COA 17-87

606 S 8th Street

Consideration of an approval for replacement of the existing metal shingle roof with 5V Crimp metal roof.

**HISTORIC PRESERVATION BOARD : PUBLIC HEARING**

Front façade

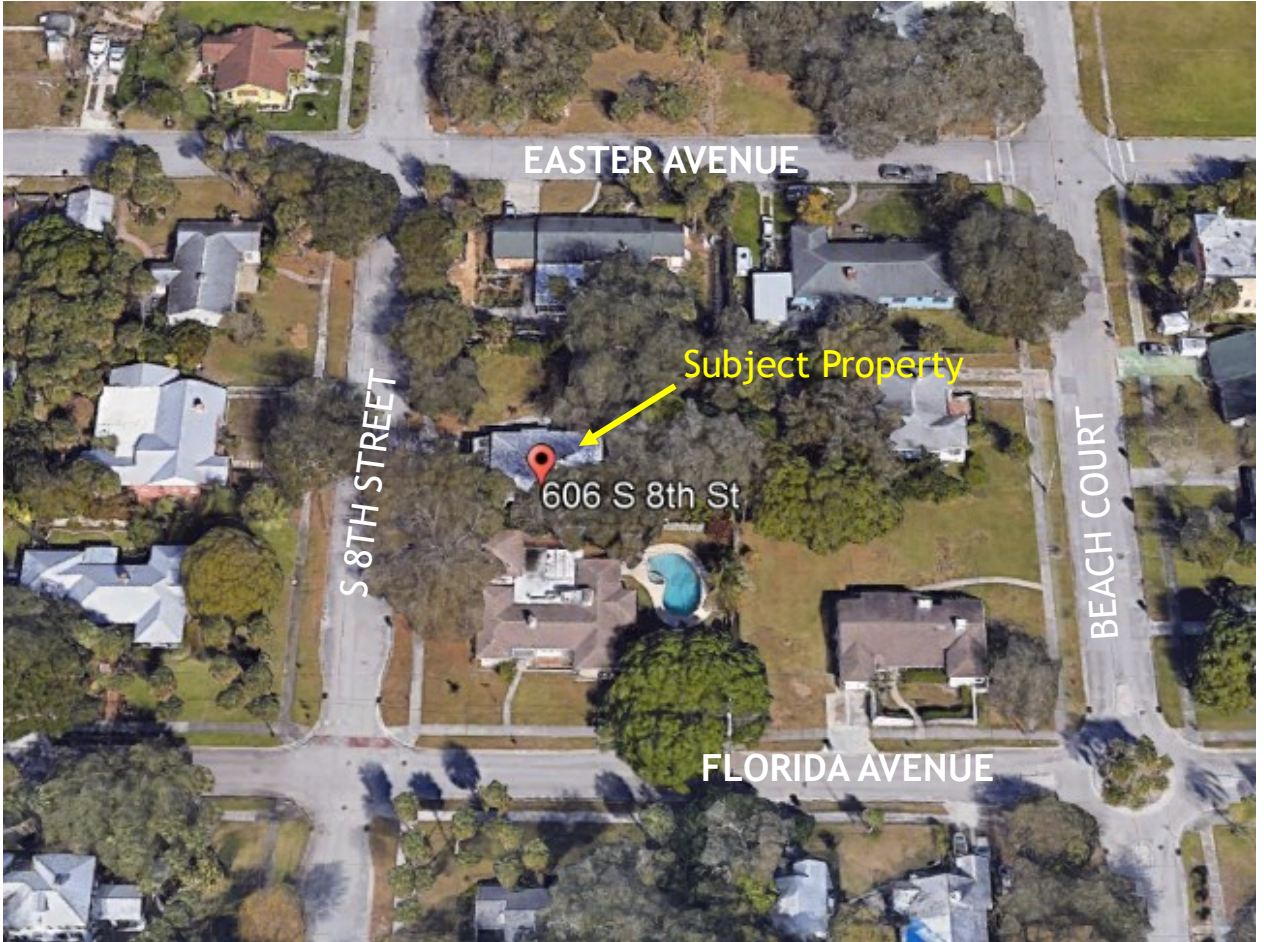
Identifying, retaining, and preserving roof materials are extremely important in defining a building's overall historic character. The replacement of the existing metal shingle roof with 5V Crimp metal roof alters the design and presents conflicts with the architectural and historical aesthetics of the structure. As stated in the Secretary of the Interior's Standards for Rehabilitation "Where the severity of deterioration requires replacement of a distinctive feature, the new feature will match the old in design, color, texture, and, where possible, materials".

The request to replace the existing metal shingle roof with 5V Crimp Metal Panels presents a conflict with Secretary of Interior Standards, therefore staff recommends that the Board deny the request or condition the request approval upon the utilization of metal shingles.
